SECTION 4.55 (1A) APPLICATION TO AMEND SSD 10437 - WATERLOO METRO QUARTER OSD SOUTHERN PRECINCT

This letter has been prepared by Urbis on behalf of WL Developer Pty Ltd (the applicant) with regards to a Section 4.55(1A) application to modify State Significant Development (SSD) Waterloo Metro Quarter OSD Southern Precinct SSD-10437.

The modification application seeks for minor internal and external design changes to Building 3 and the landscaping. The majority of the proposed changes are internal and considered to be minor. The external changes relate to minor landscape changes, configuration of rooftop plant and inclusion of additional louvres.

Approved Building 3 Roof Plan

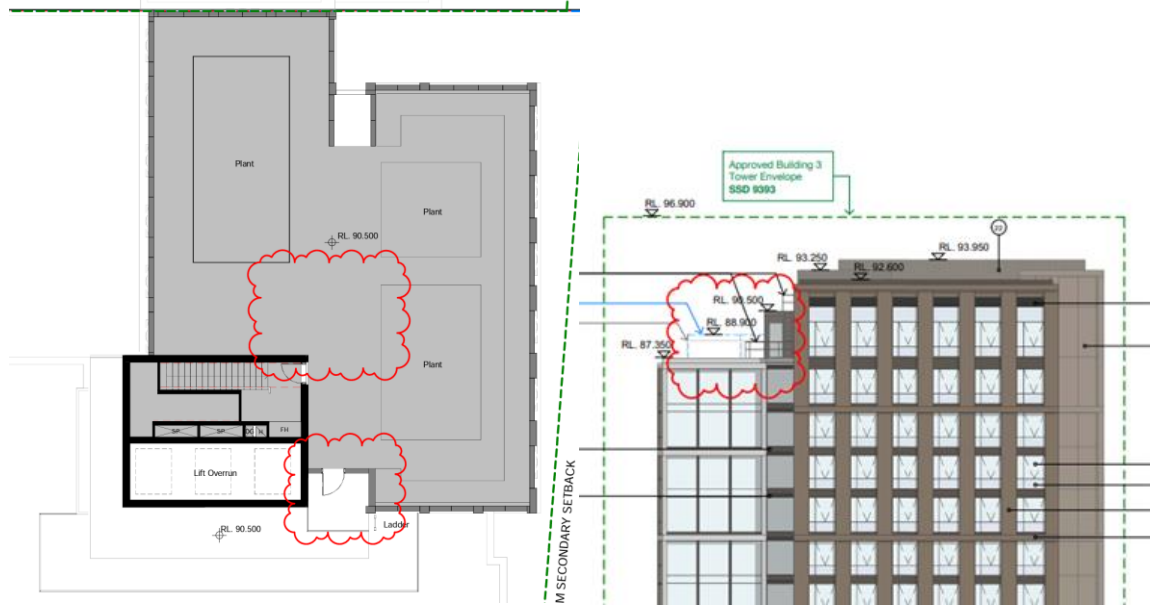
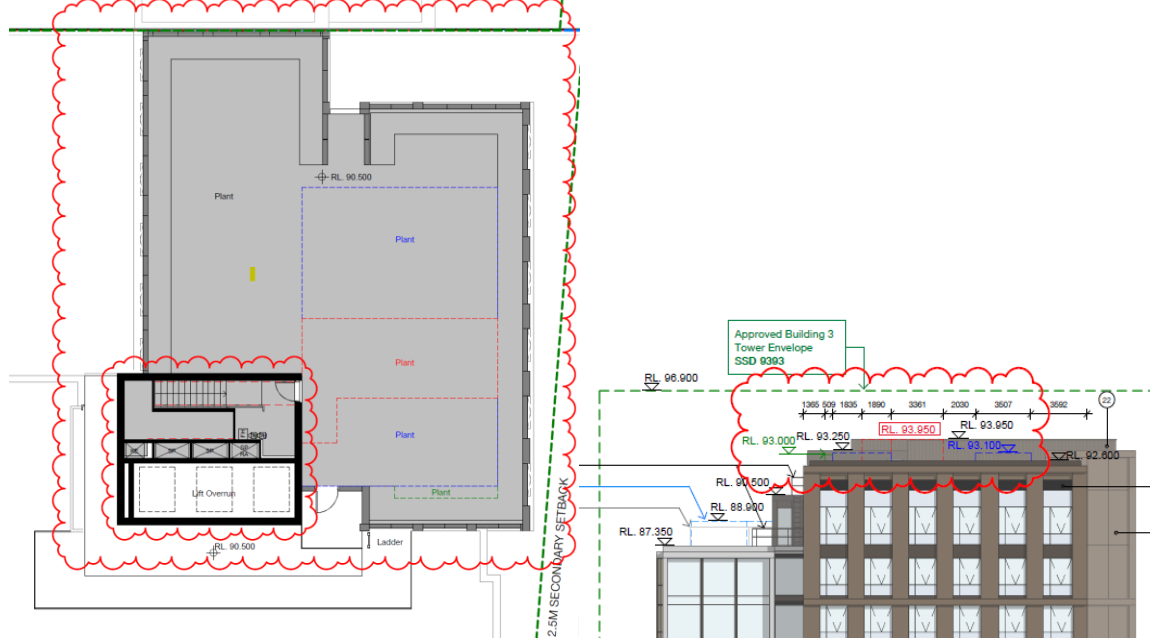
- Revise roof plant zones
 - Increase height of plant zones, not exceeding the approved Concept building envelope (RL96.9) (see below comparison of plans);
- Addition of louvre for ventilation on western elevation to Level 24 lift core
- Additional service doors to podium roof
- Addition of louvres to podium of the mezzanine level and Level 1.
- Addition of louvres to northern elevation of the ground level and Level 2

- There are no alterations to the predominant architectural design of the building.
- The revised plant zones are below the maximum height of the building, and is intended to facilitate for minor building elements. The maximum height of the building is retained and the building remains consistent with the concept DA.

- The revised plant zones are setback from the building edge and is not readily visible from the public domain.
- As the plant zones are for small roof top elements and do not exceed the maximum building height, they do not significantly impact view corridors.
